SERVICE BULLETIN

N° 139-615

ATA 00 – INSTALLATION OF SPECIFIC VARIANTS FOR OFFSHORE CONFIGURATION

This Service Bulletin is issued in order to provide the necessary instructions to perform the installation of some modifications required by the Customer to align the configuration of its fleet.

Figure 4

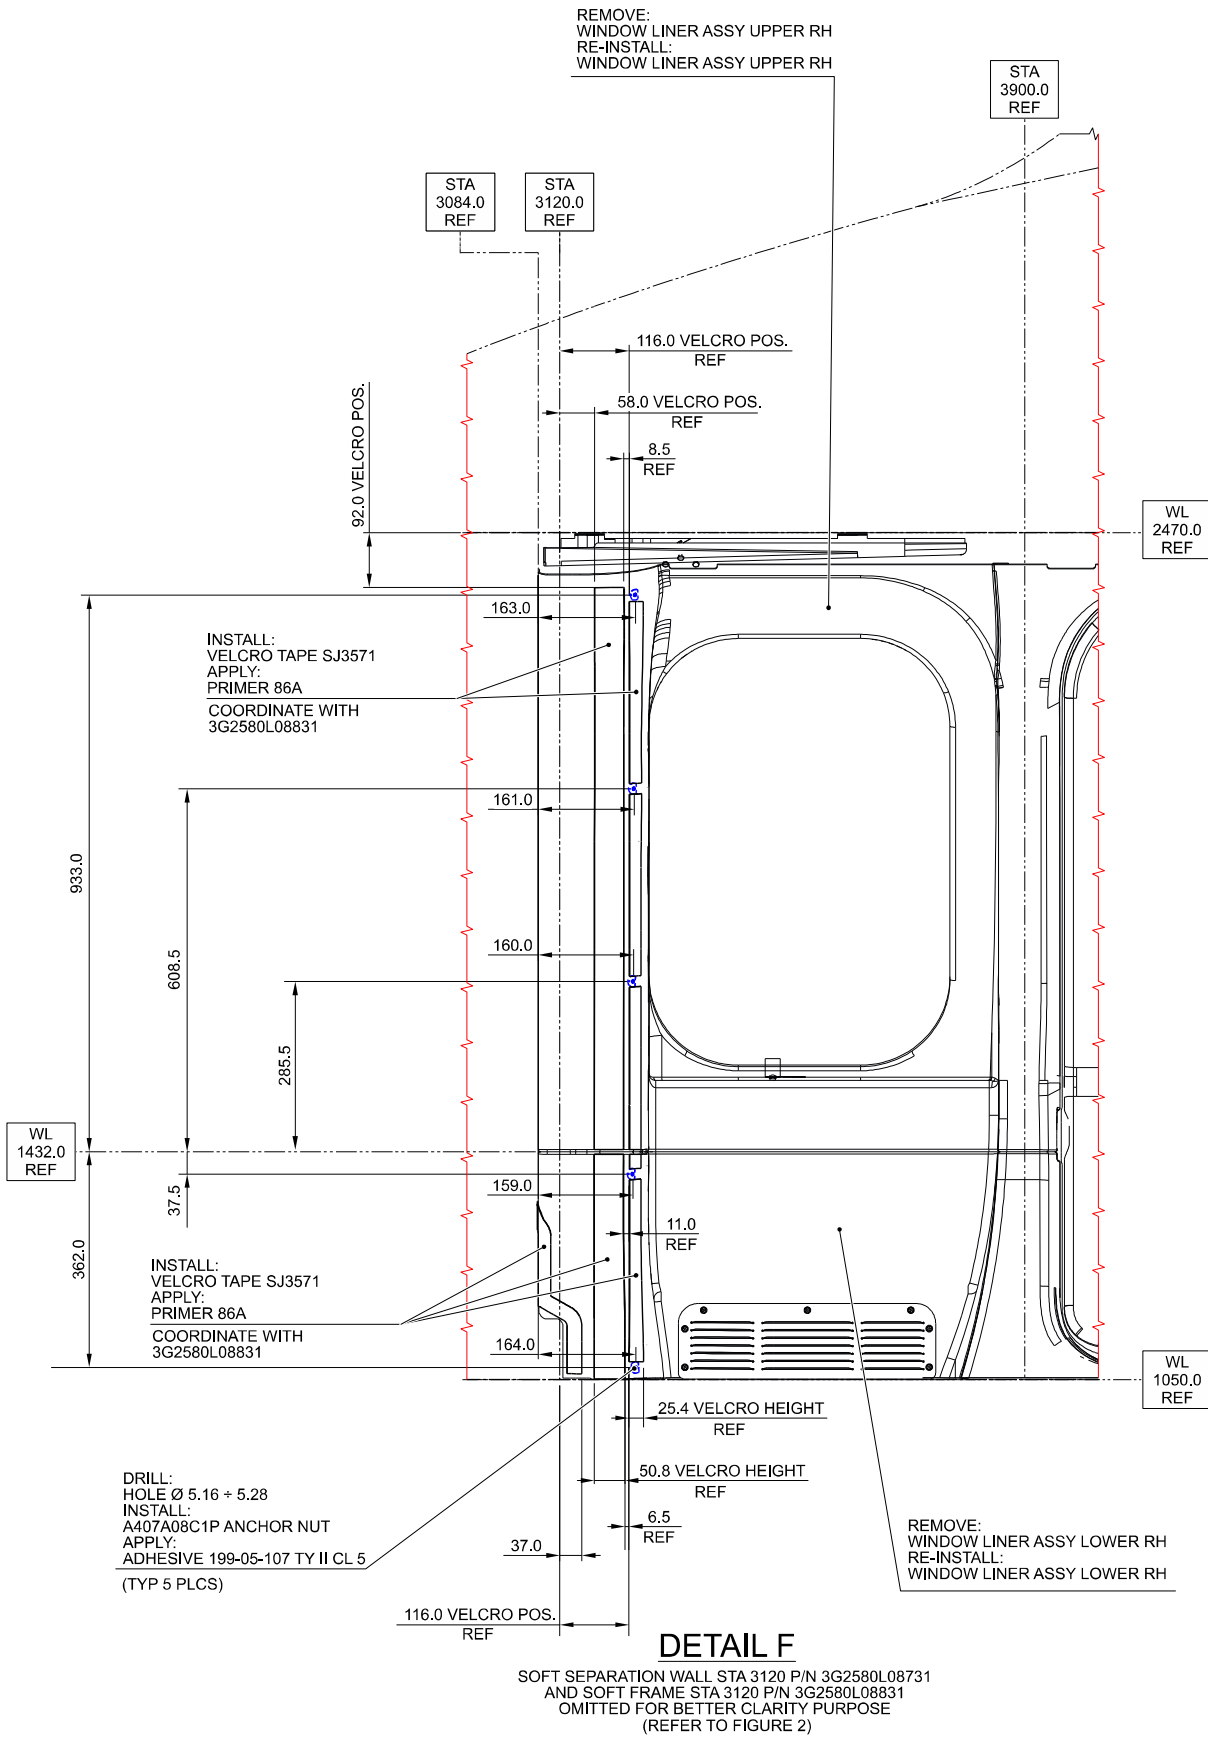
- 4.3 With reference to Figure 4 Detail F, drill n°3 holes Ø5.16÷5.28 on the window liner assy upper RH.
 - 4.4 With reference to Figure 4 Detail F, drill n°2 holes Ø5.16÷5.28 on the window liner assy lower RH.

- 4.5 With reference to Figure 4 Detail F, install n°5 anchor nuts P/N A407A08C1P by means of adhesive 199-05-107 Type II Class 5 on the window liner assy upper RH and window liner assy lower RH.

- 4.6 With reference to Figure 3 Section B-B and Figure 4 Detail F, install the Velcro tape SJ3571 by means of the Primer 86A on the window liner assy upper RH and window liner assy lower RH, in accordance with the dimensioning shown.

Figure 5

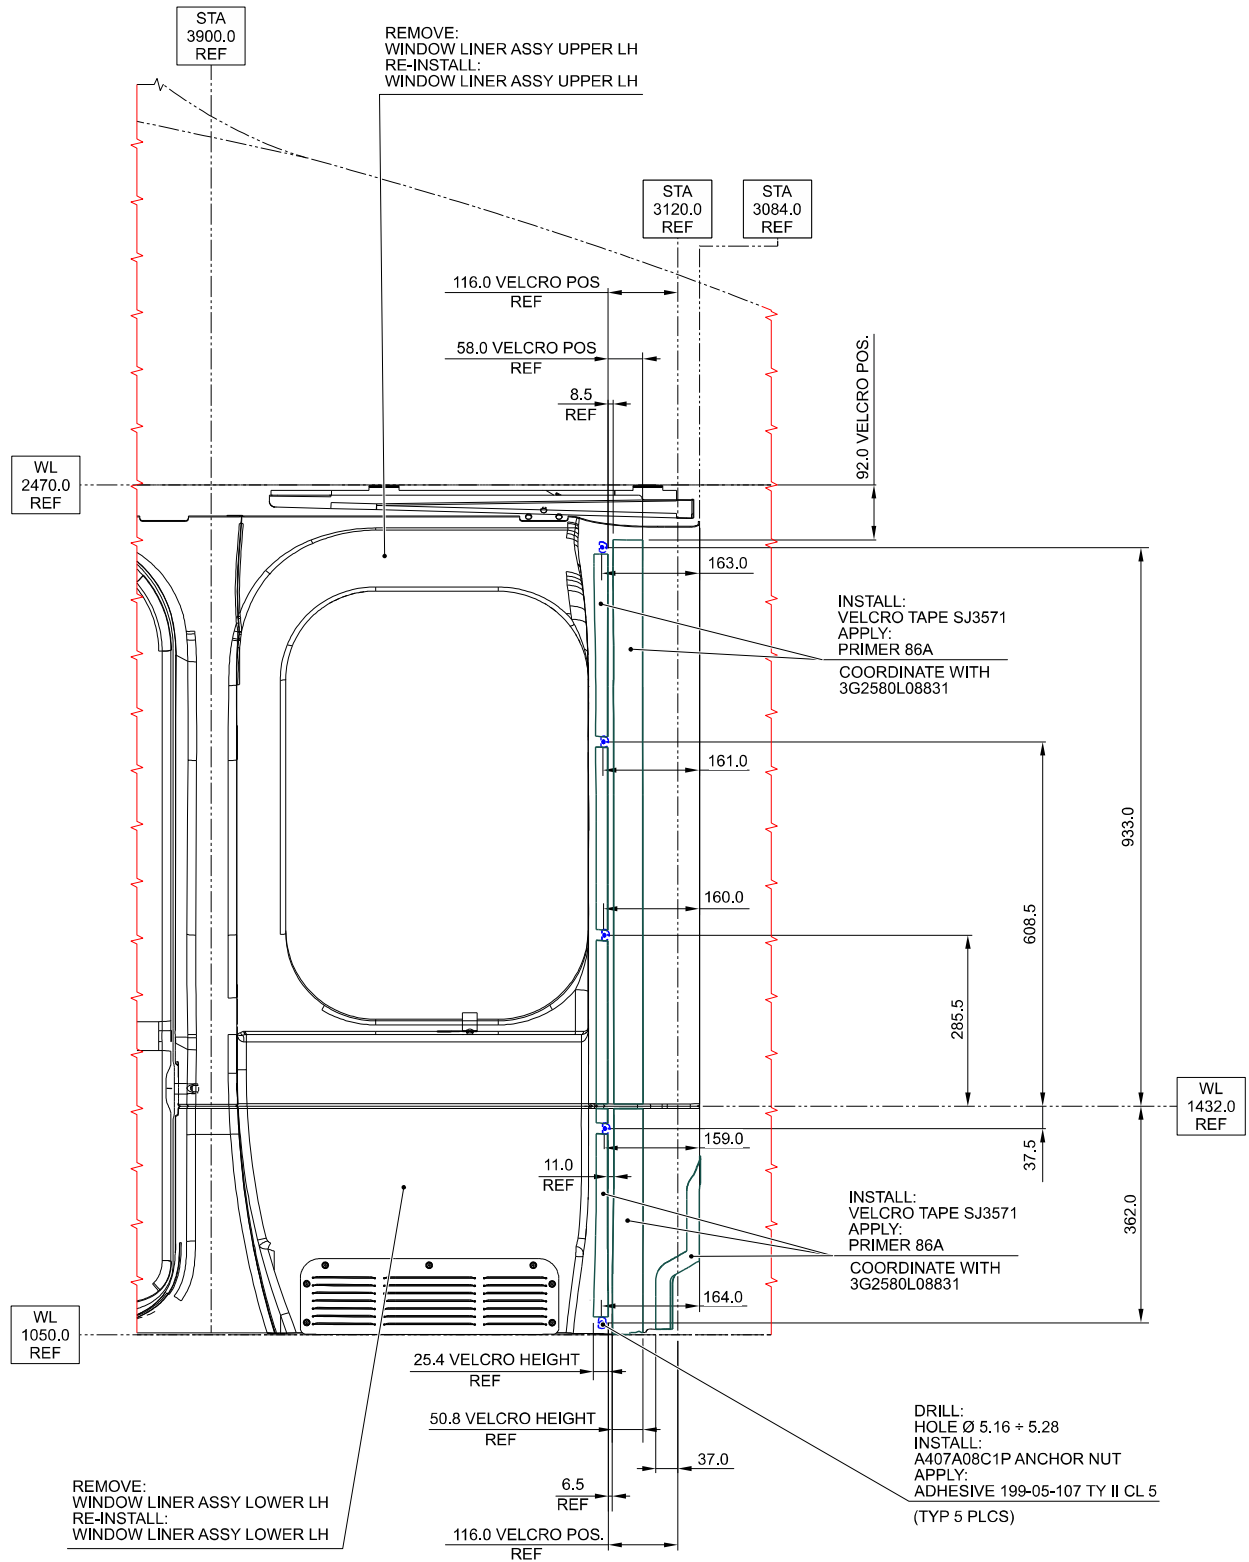
- 4.7 With reference to Figure 5 Detail E, remove the window liner assy upper LH, the window liner assy lower LH and retain existing hardware for later reuse.

- 4.32 With reference to Figure 5 Detail E, install the window liner assy upper LH on the structure by means of the existing hardware.
 - 4.33 With reference to Figure 5 Detail E, install the window liner assy lower LH on the structure by means of the existing hardware.

Figure 7

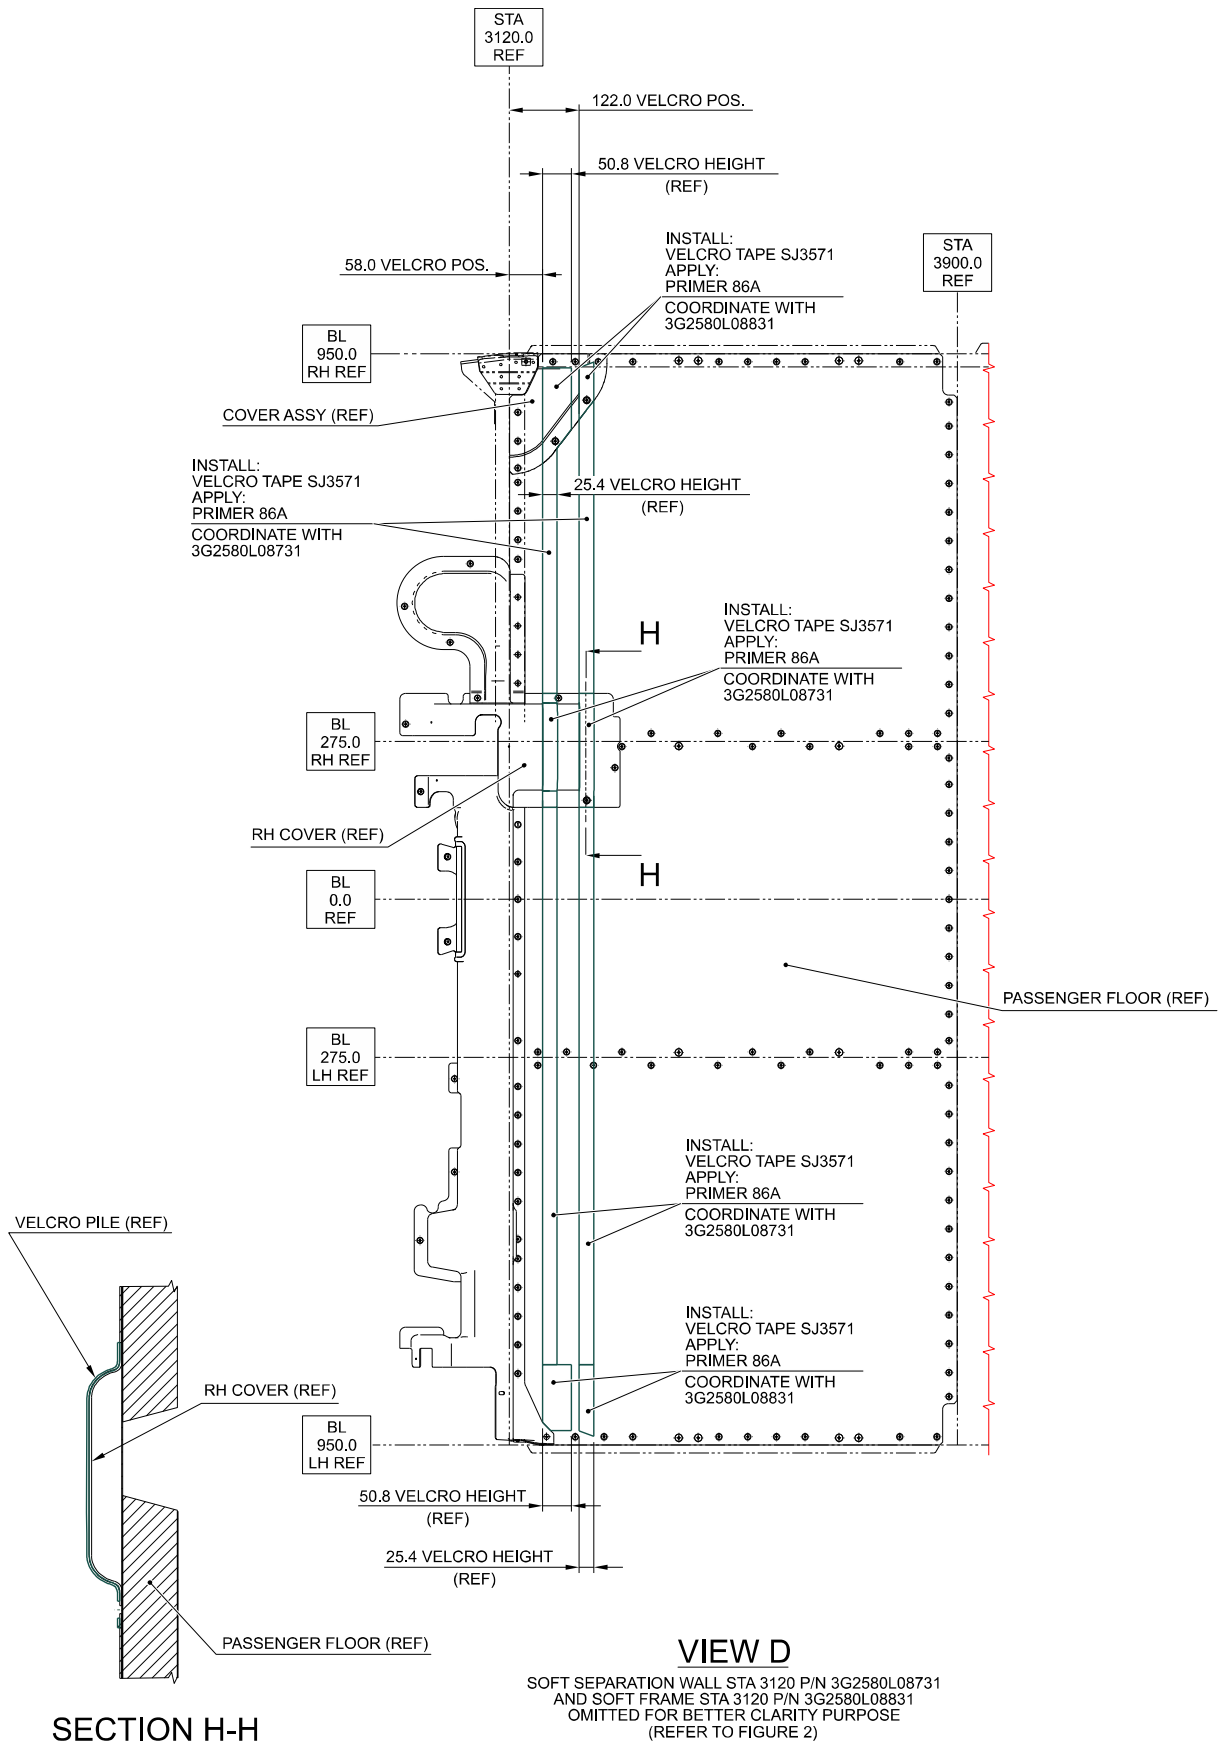
- 4.25 With reference to Figure 7 View D and Section H-H, install the Velcro tape SJ3571 by means of the Primer 86A on the passenger floor, the cover assy and the RH cover, in accordance with the dimensioning shown.

Figure 8

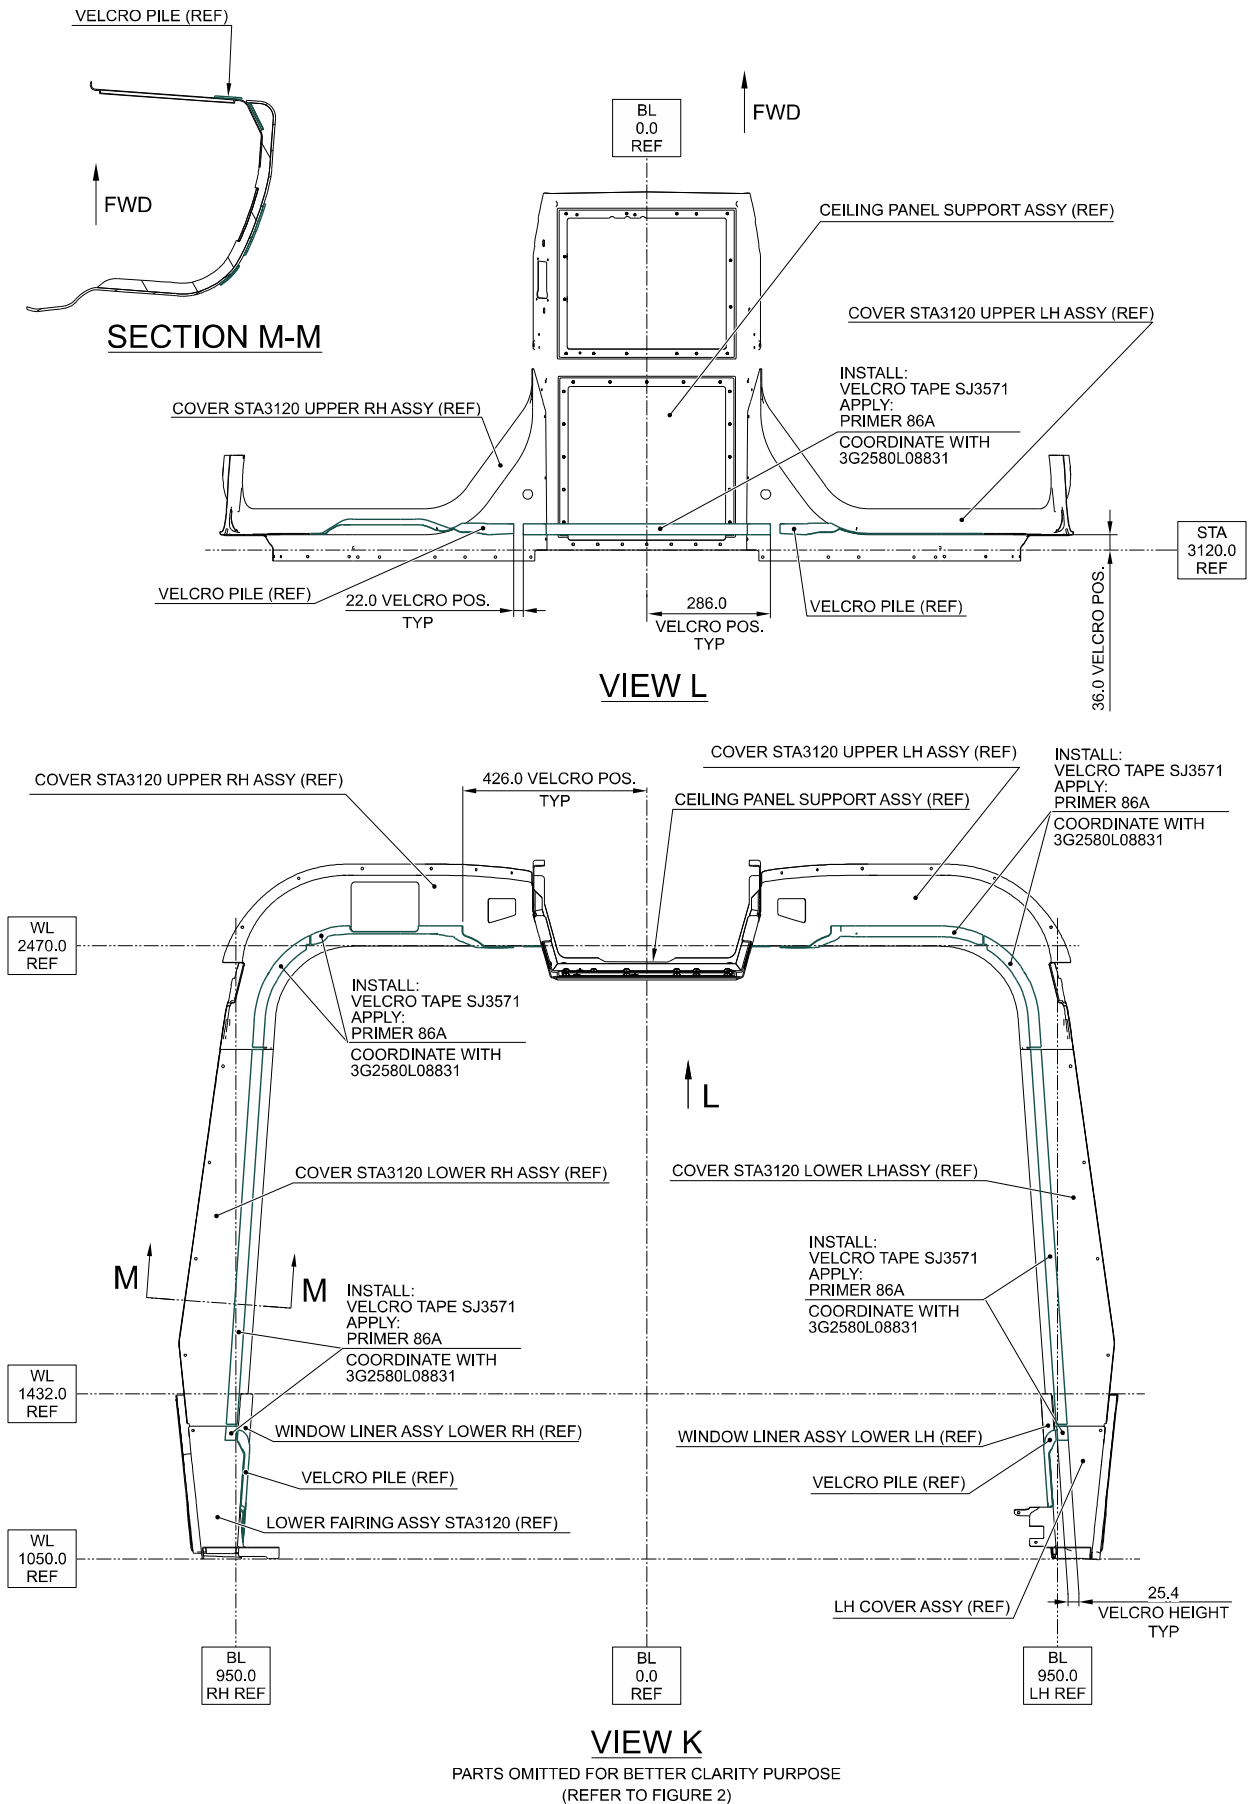
- 4.26 With reference to Figure 8 View L, View K and Section M-M, install the Velcro tape SJ3571 by means of the Primer 86A on the ceiling panel support assy, the cover STA3120 upper RH assy, the cover STA3120 upper LH assy, the cover STA3120 lower RH assy, the cover STA3120 lower LH assy, the lower fairing assy STA3120 and the LH cover assy in accordance with the dimensioning shown.

Figure 9

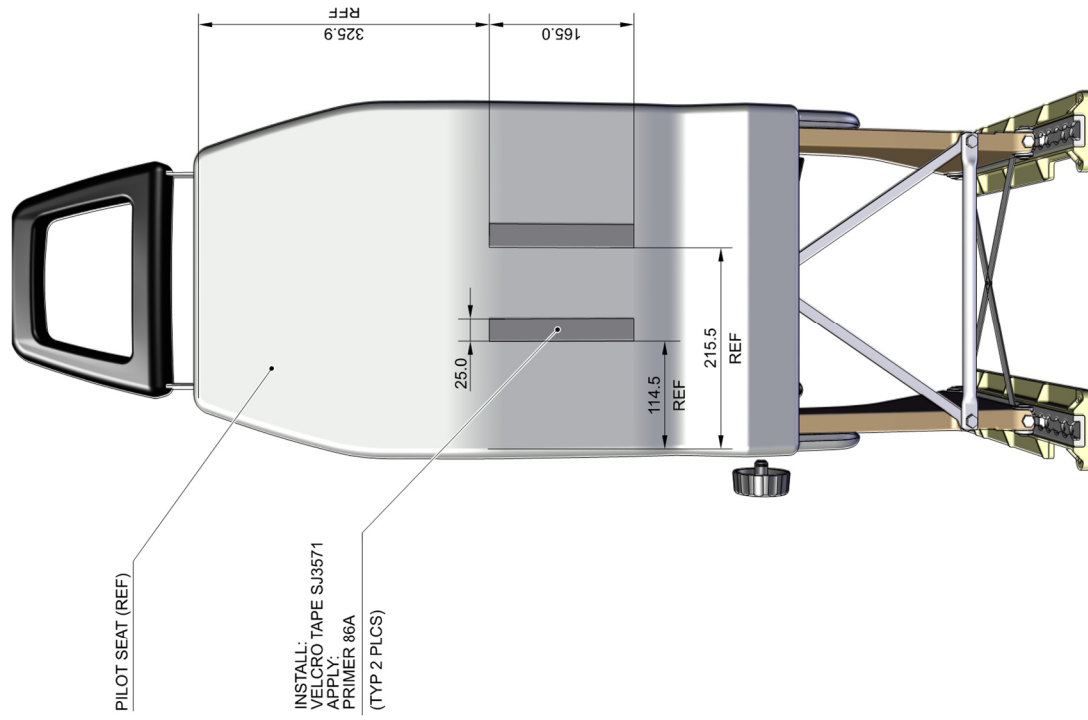
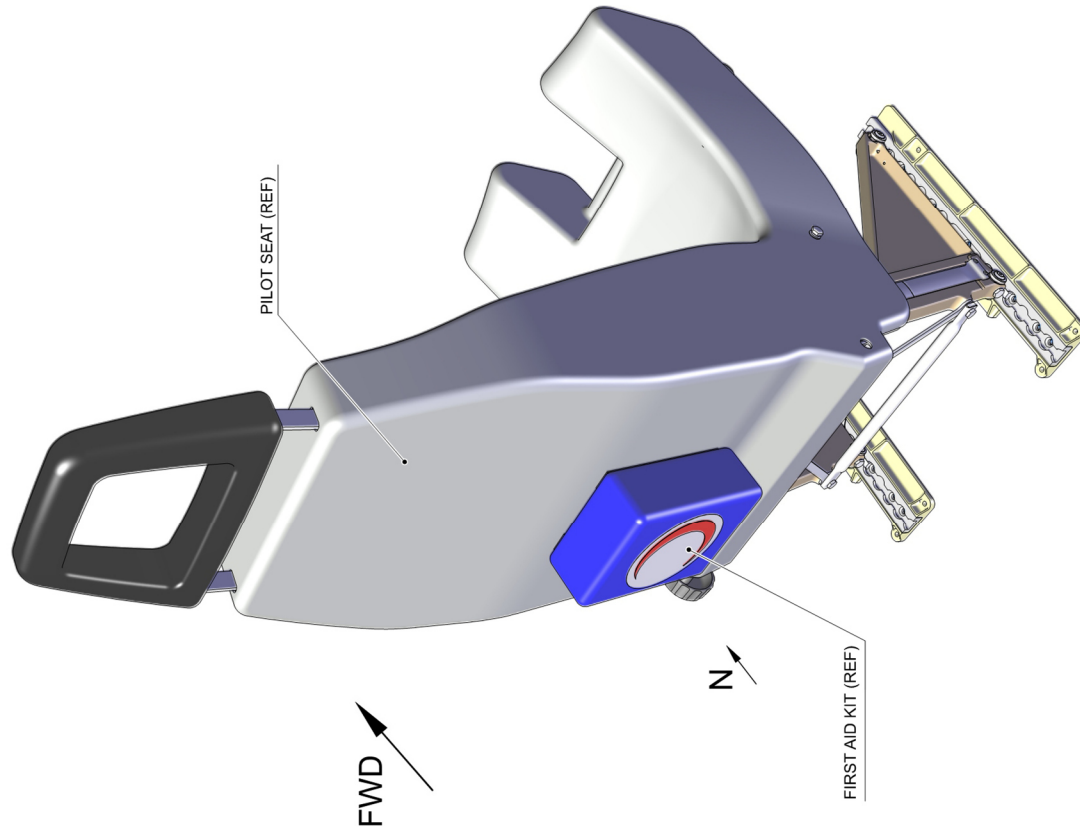
- 4.43 With reference to Figure 9 View N, install the Velcro tape SJ3571 by means of the

Primer 86A on the rear of the pilot seat, according to the dimensioning shown.

- 4.44 With reference to Figure 9 Pilot seat Isoview, install the existing first aid kit in the new position on the rear of the pilot seat.
5. In accordance with weight and balance changes, update the Chart A (see Rotorcraft Flight Manual, Part II, section 6).
6. Return the helicopter to flight configuration and record for compliance with Part I of this Service Bulletin on the helicopter logbook.
7. Send the attached compliance form to the following mail box:
